# **SERVICE BULLETIN**

**NUMBER:** 15-289-21

**SUBJECT:** Subaru STARLINK® Owner's Manual Correction

For Denso CP1 Gen 4 Systems

# A - Apple CarPlay: Additional Information in RED. (Actual printed version will be different)

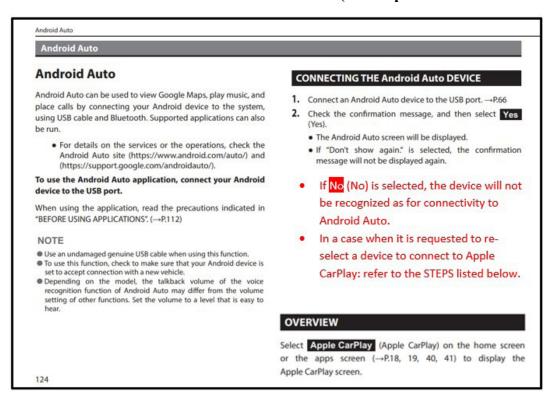
- **STEP 1)** Select the Settings button from the home screen.
- **STEP 2)** Select the Phone button from the top row.
- **STEP 3)** Select the Apple CarPlay arrow.

**STEP 4)** Select the Device List button.

### **STEP 5)** Select the Edit button.

- **STEP 6)** The desired connection can be customized by selecting and/or deselecting the devices listed on the check list that is displayed.
- STEP 7) Select the BACK button when the desired selection is complete.

## B - Android Auto: Additional Information in RED. (Actual printed will be different)

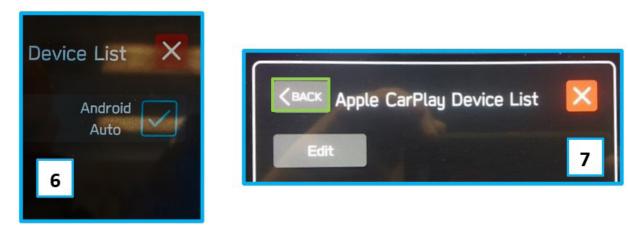
- STEP 1) Select the Settings button from the home screen.
- **STEP 2)** Select the Phone button from the top row.
- STEP 3) Select the Android Auto arrow.

- STEP 4) Select the Device List button.
- STEP 5) Select the Edit button.

- **STEP 6)** The desired connection can be customized by selecting and/or deselecting the devices listed on the check list that is displayed.
- **STEP 7**) Select the BACK button when the desired selection is complete.
